SVP Follow Up Questions to
Joint SVP/SMUD/TID IBAA Questions
February 29, 2008

SVP appreciates the CAISO responding to the joint SMUD/TID/SVP questions. While the CAISO did answer many of the questions, it did not respond to others, or its responses were not complete. To further stakeholder understanding of the issues, SVP is summarizing its understanding of the CAISO's response(s) to some of the questions (either from written responses or from the stakeholder conference calls), and is clarifying some of the questions. The original questions are shown in black type, while the summaries and the follow-up questions are shown in blue type. Please indicate if SVP is correctly describing the CAISO's responses and please respond to the questions below. If possible, please provide your response to these questions prior to the March 6 meeting.

Source: Hourly Congestion Components of LMP in April 2005 in the LMP Study 3C

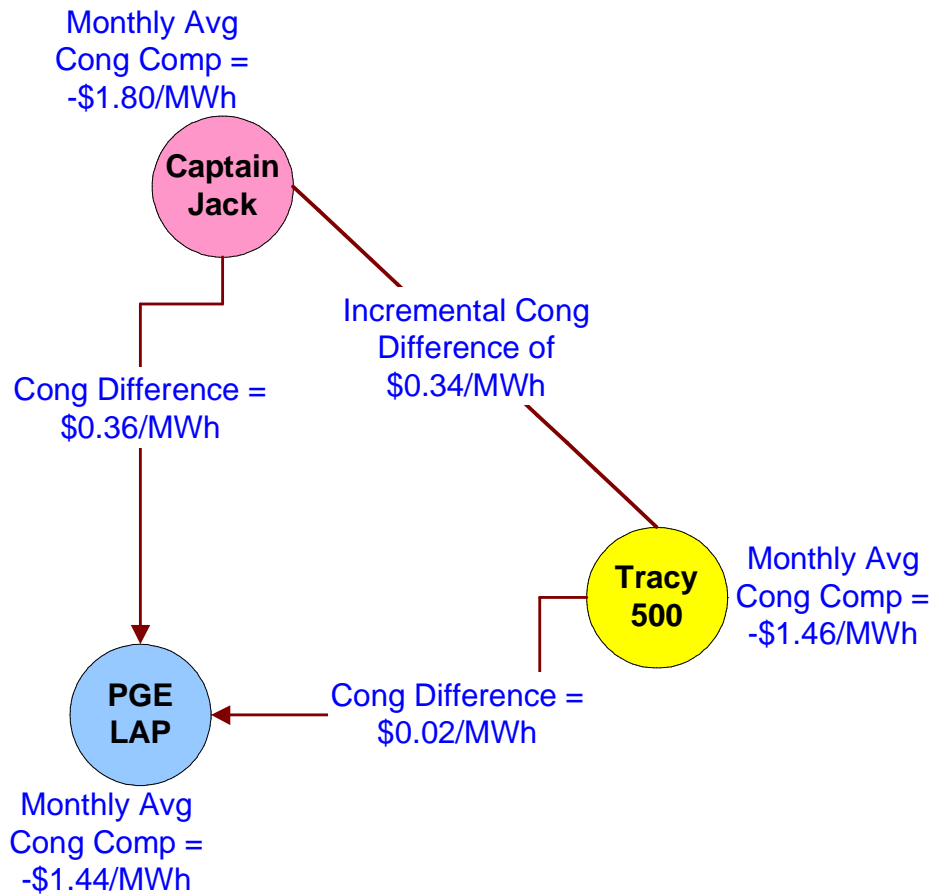
would be required to hedge congestion between Captain Jack and Tracy, even though the COTP project is not part of the CAISO Balancing Authority Area or the CAISO Controlled Grid. Please explain how a Tracy CRR obligation mapped back to Captain Jack does not place additional burdens on COTP owners that do not exist under the current market structure.

[SVP believes that the CAISO has not responded to this question. SVP hopes the example below helps illustrate the issue and will enable the CAISO to respond to the question above.

Consider the average congestion components at Tracy 500, Captain Jack and PG&E Default LAP for April 2005 (from LMP Study 3C). The figure below shows that the average congestion between Tracy 500 and the PG&E Default LAP for April 2005 was \$0.02/MWh. The average congestion between Captain Jack and the PG&E Default LAP was \$0.36/MWh. If a party scheduling COTP Imports at Tracy does not hold a CRR mapped to Captain Jack, it would be exposed to \$0.34/MWh more congestion than it would have been if the injections were priced at Tracy. While the CAISO would make available CRRs mapped to Captain Jack to provide a Day Ahead hedge for the entire \$0.36/MWh congestion exposure, this CRR is an obligation, rather than an option. Holding the Captain Jack – PG&E Default LAP CRR is inherently more risky than holding the Tracy – PG&E LAP CRR. COTP participants previously had the option to schedule injections at Tracy, but once they hold the CRR, it becomes an obligation (since they risk paying counter-flow congestion). Also, once they hold the Captain Jack – PG&E LAP CRR, they no longer have the ability to capture the South – North value of the COTP line for the periods covered by the CRR. SVP believes this reduces the value of the COTP line to it and other COTP participants. With this explanation, please respond to the question previously posed in 3.g.]
